SS: 1034650 TBB Minotour water intrusion

This Service Solution does not imply any special warranty coverage. Standard warranty guidelines and coverage apply. This Service Solution is provided to report a product improvement in preventing water / dust intrusion in the drivers vestibule area.

BIW – MINO

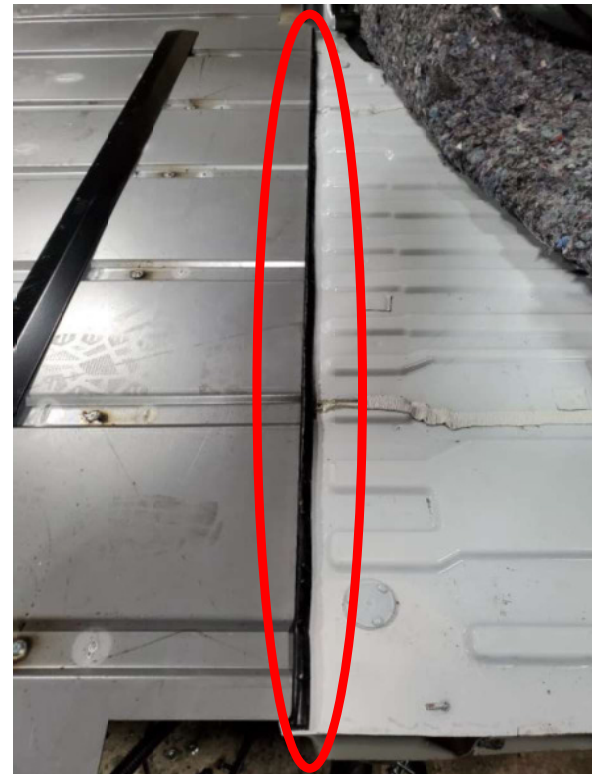
Noticing floor board carpet getting wet

Add 68000160 at transition of steel floor to cab on flat portion completely across the cab. Tuck 68000160 under steel floor at raised locations.

Cowl Sealant – K3A20 (68000160)
